Pennsylvania Department of Environmental Protection

Telecopy Transmittal

Safety Light Response to the
Work Plan questions.

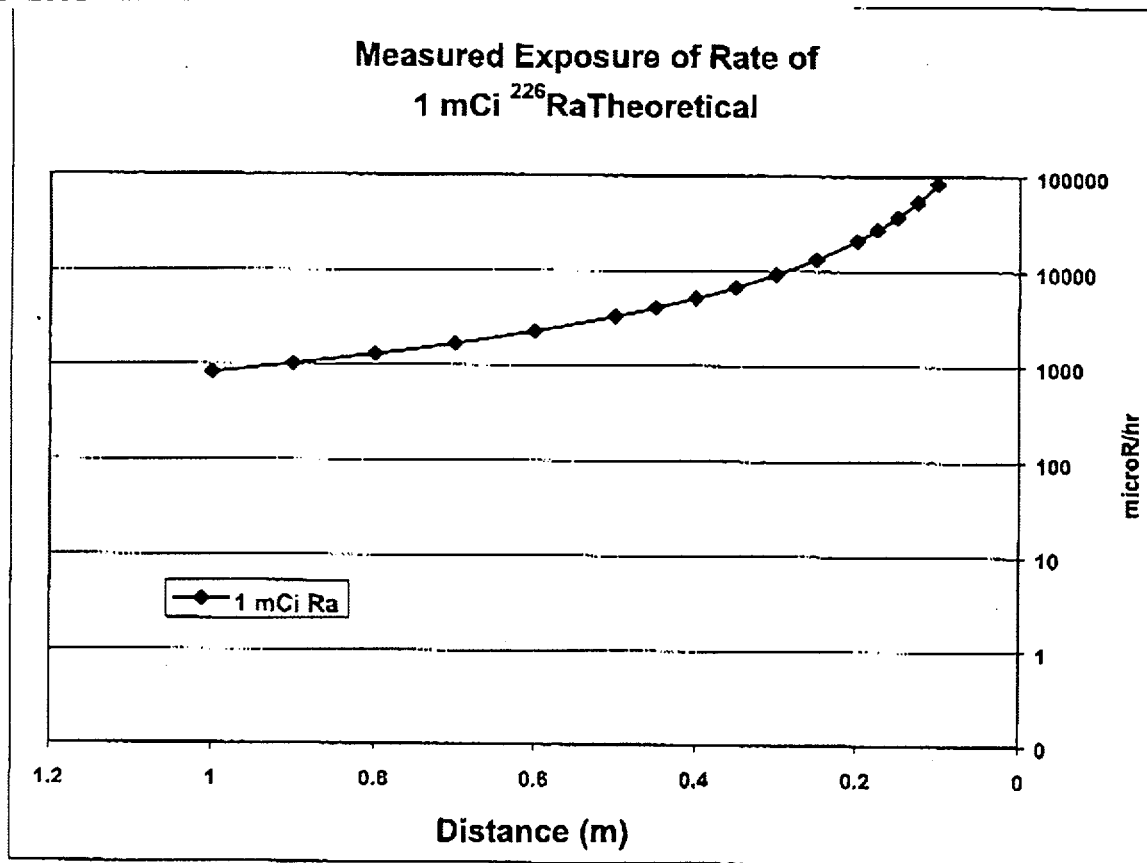
- 13. Section 11.1 refers to a dose vs. distance conversion for Ra-226, which follows. However, the information is missing from this section.**

To quantify the activity, the exposure rate of an item with a near point geometry will be measured at several distances and compared to the theoretical exposure rates from a one (1) milliCurie point source of radium, as shown on the following graph. Items with a very low activity may be grouped to reduce measurement error. Data obtained during the project will be plotted and the resulting lines compared to determine the shape of the measured data.
